**Céide Coast Community Company Ltd,  
Eco Campus, Main Street,  
Ballycastle  
Co. Mayo F26 W544**

Glenora Windfarm (An Coimisiun Pleanala Ref. 318701-23)

## Ceide Coast Community's Concerns

Figure 1-5 Zone of Theoretical Visibility of the Proposed Turbines from the Proposed Walking Route

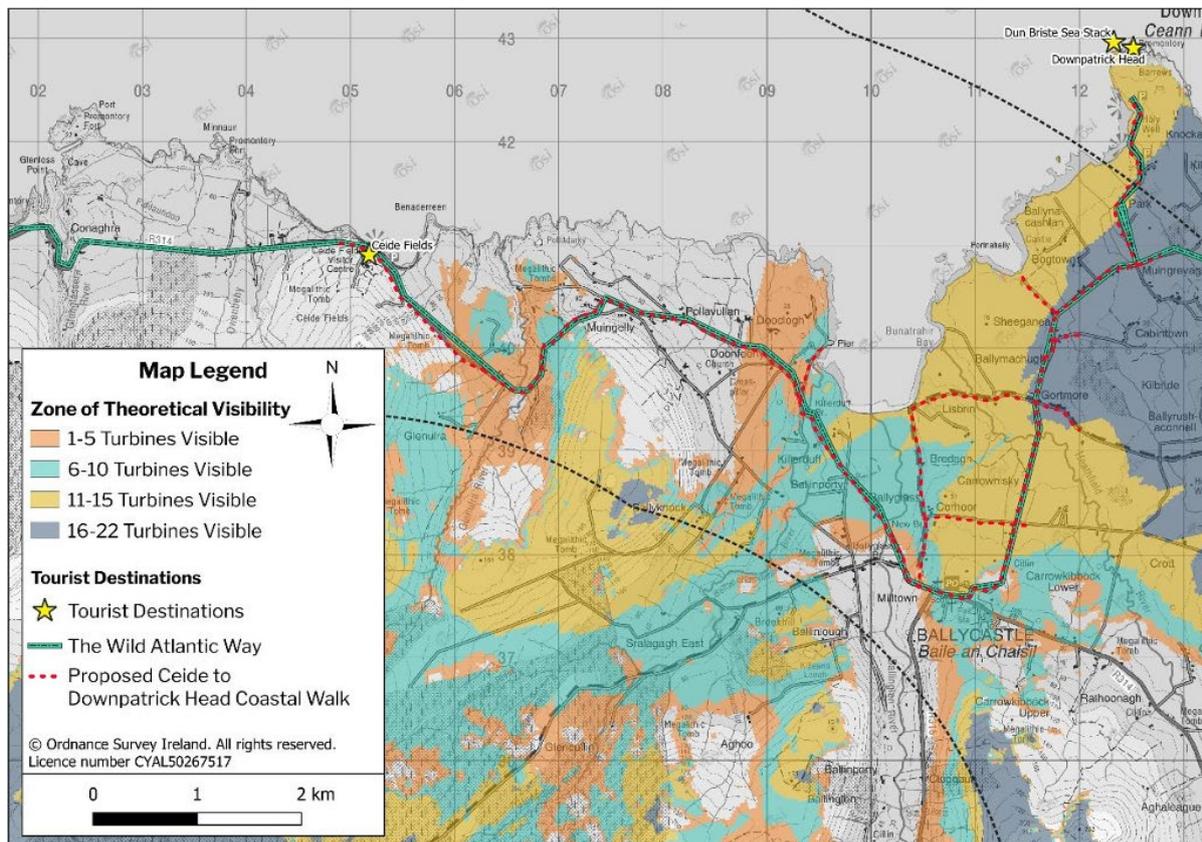
Figure 1-5 shows (Also Appendix 2 for clarity) these 'Zones of Theoretical Visibility' on a legend with various colours representing the number of turbines that would be visible from each shaded location. Logic would now indicate that if the position of the 'assumed coastal walk' is now in reality moved to its real location directly adjacent to the Atlantic Ocean and along the physical coastlines edge from the Ceide Fields to Downpatrick Head (further back and way from the hills of Ceide, Glenurla, Muingelly and Ballycastle) then these shaded zones on Figure 1-5 are incorrect. A truer and more accurate map should have shading showing much higher number of turbines but this is not the case.

Over 5km is not the distance from the nearest turbine to the actual proposed coastal walk. It is in fact a greater distance back towards the sea from the hills which now logically results in a greater number of turbines being visible from the shaded areas as shown in Figure 1-5. The number will be much more than has been described incorrectly by the applicant. If this is the level of scrutiny and assessment within this chapter of the reporting and EIAR, then we as a community would have serious reservations and concerns with regard to the rest of the EIAR chapters and their content.

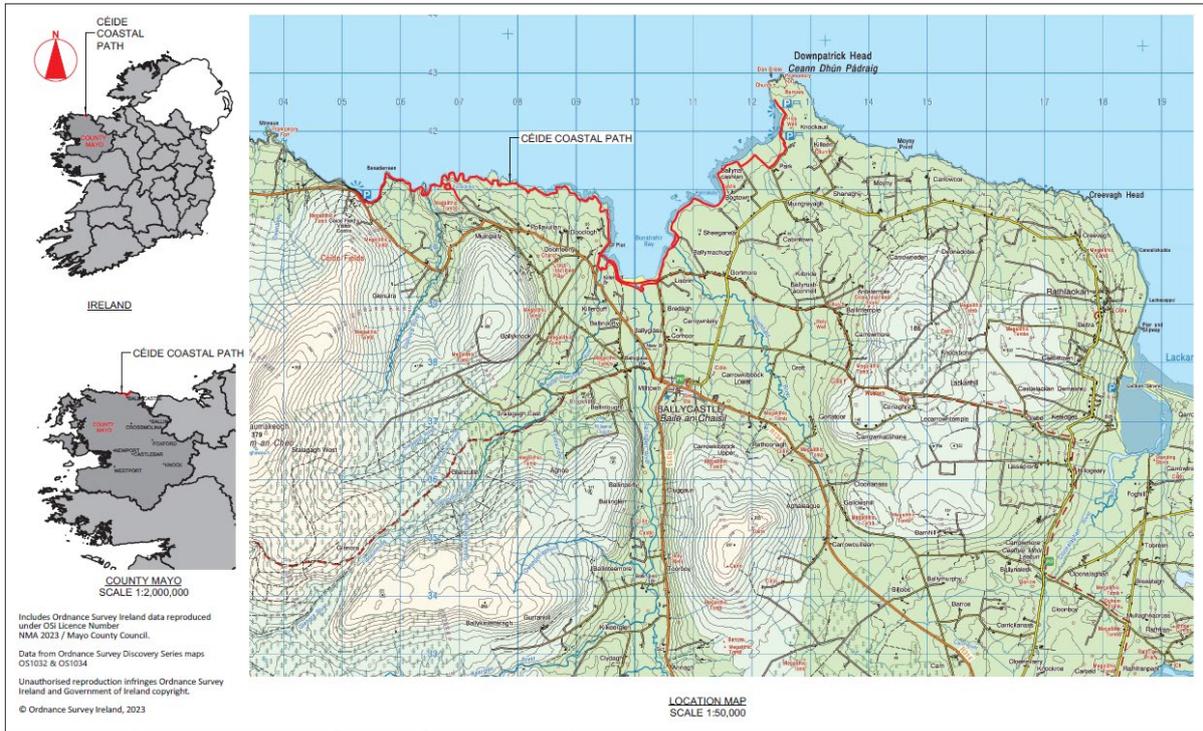
To state that ‘there will be a ‘Not Significant’ visual effect overall on the proposed Ceide Coastal Walk from the Ceide Fields to Downpatrick Head as a result of the proposed Glenora windfarm development is categorically incorrect and disingenuous.

Actual route (in red) of the proposed Ceide Coastal Walk as drawn by the assigned engineering company CAKE to the project (Appendix 3).

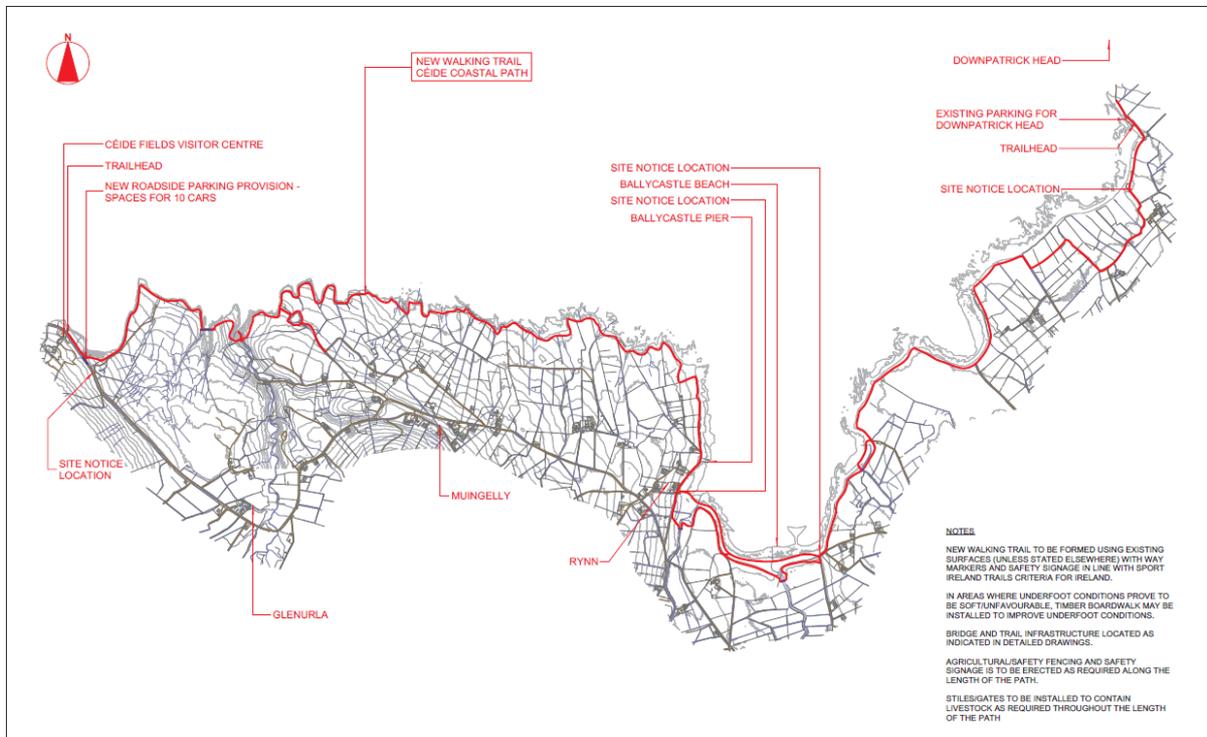
The statement that ‘the proposed walkway follows the same route as that of the Wild Atlantic Way’ is also categorically incorrect.

Plate 1-2 Extract from the CCCC page on the Ceide to Downpatrick Head Coastal Walk (accessed 08.04.2024)

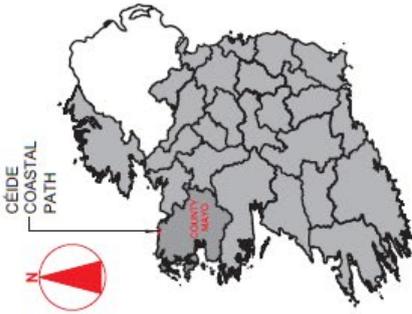
The above map was then referred to stating that it "shows a proposed extent of the route from Downpatrick Head to the Ceide Fields visitor centre"

In this instance, the applicant has rather naively assumed that the black line on the map represents the proposed coastal walk. This categorically not true (Actual coastal walk as drawn up by an engineering company designated for the project shown in Appendix 3).

Firstly, the map referred to above contains detail with regard to the '30 signature points' a number of which can clearly be seen marked along the actual physical coastline itself adjacent to the sea. This same map clearly states that relevant landowners have signed up for the walk. In this instance, it is incorrect to assume and imply that the walk would follow the trail of the R314 Ballycastle to Belmullet Road. There would be no logic in having a 'coastal walk' away from the coast and on the same conduit as a high number of tourist traffic which traverses the route on a regular basis between Downpatrick Head and the Ceide Fields.
